BIGGS & MATHEWS INC.
Consulting Engineers

RE: Review & Comments – First Tier Subdivision
Final Plat – Denver Road Estates
79.18 Acres – Lots 1 Thru 20
Montague County, Texas

RE: Groundwater Availability Certification Report – Denver Road Estates

National Flood Hazard Layer FIRMette

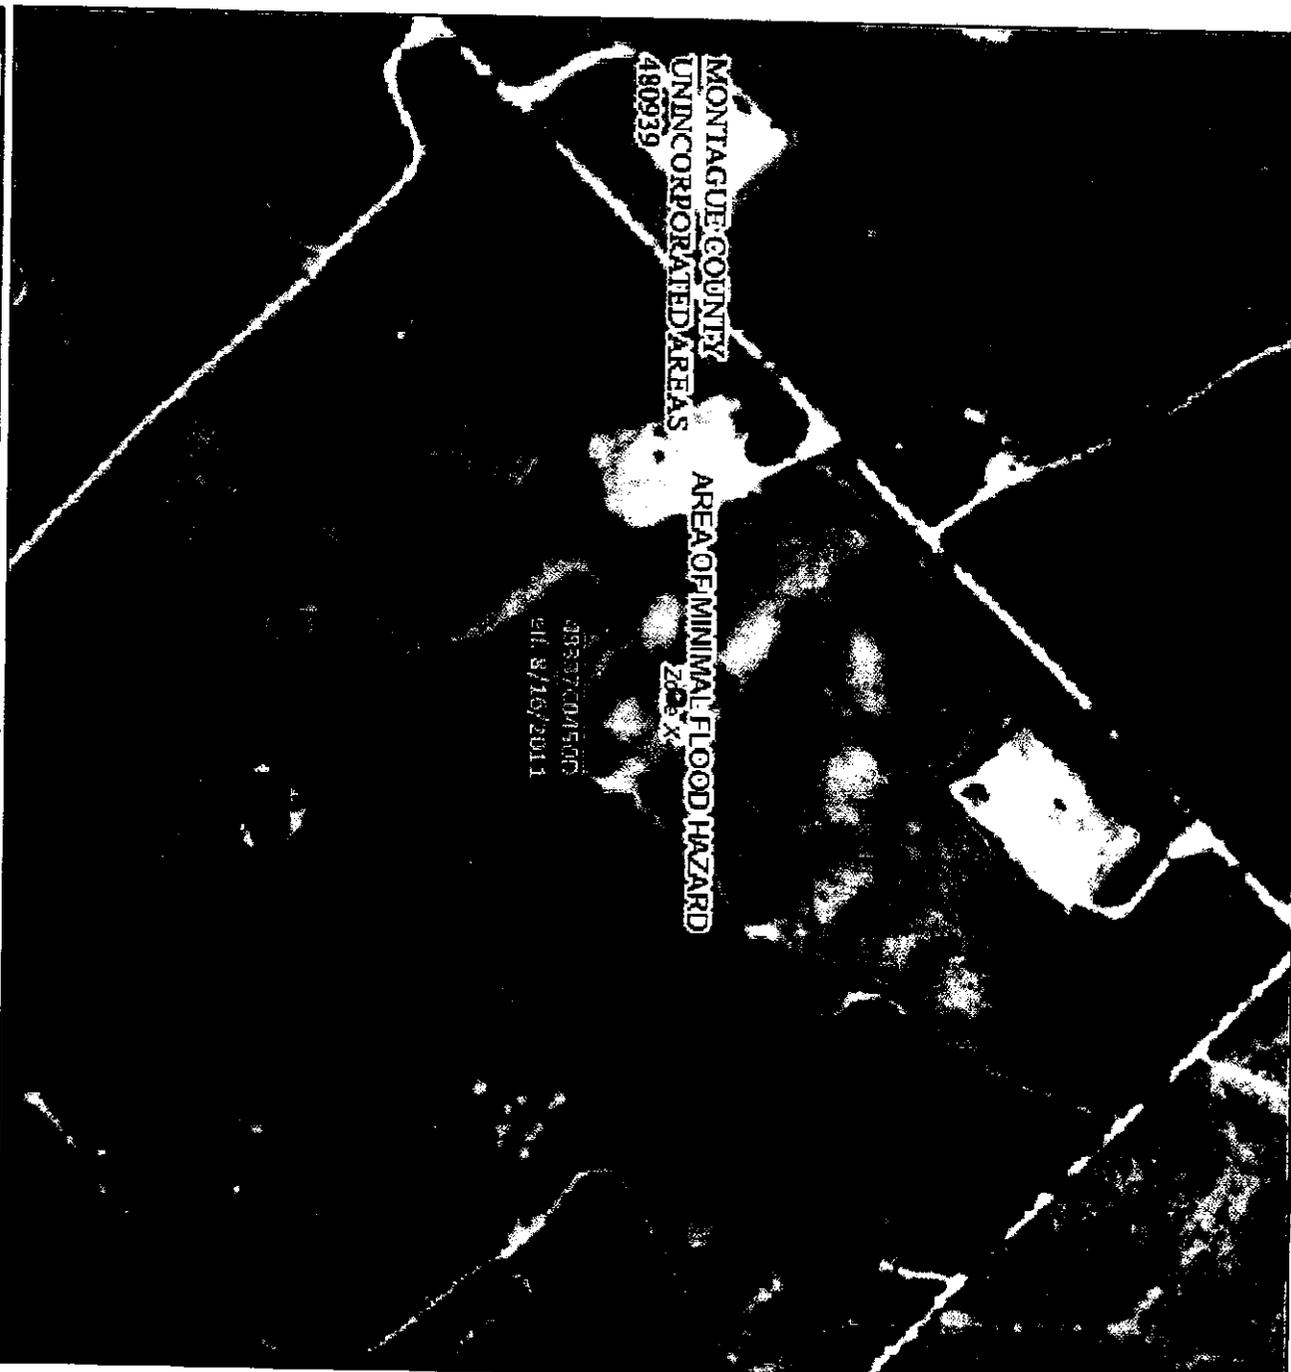
- 14) ** All 100-year floodplains – Floodplain Map Not Provided*
- 15) *Road names or numbers for all roads or streets ✓*
- 16) *Lot and block numbers arranged in a systematic order ✓*
